Town of Scarborough, ME

RFP #152026

Municipal Two-Way Radio Communications System Upgrade

ADDENDUM #3

Current Console Position Configuration:

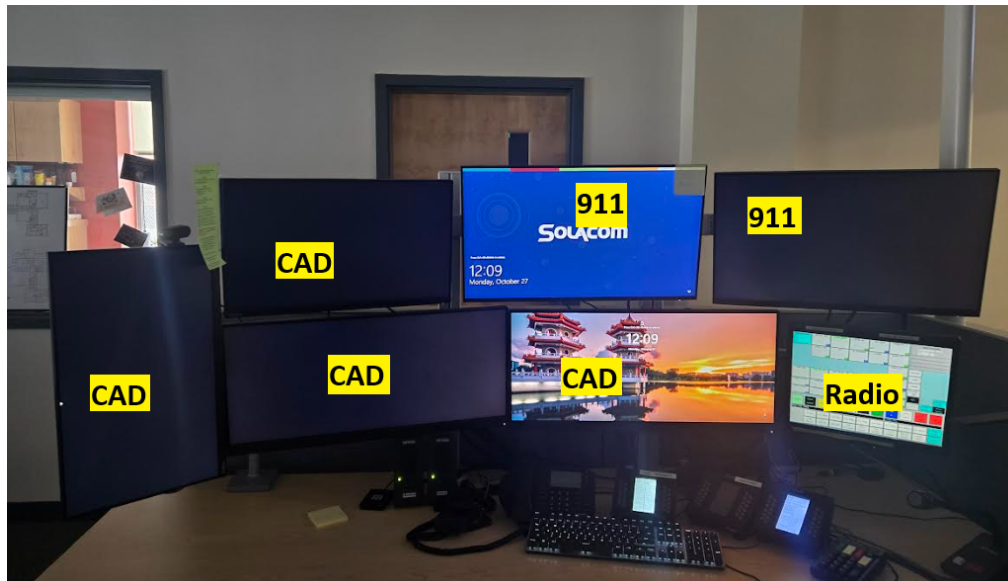
1a - How many monitors per position and what are their sizes?

1b - What is the preferred mounting configuration for the monitors? Horizontal array? Stacked? i.e., 2 over 3 for example?

CAD: 2ea, 29" ultra-widescreens, 2ea, 24" widescreen

911: 2ea, 27" widescreen

Radio: 1ea, 20" square (this will change with the new system)
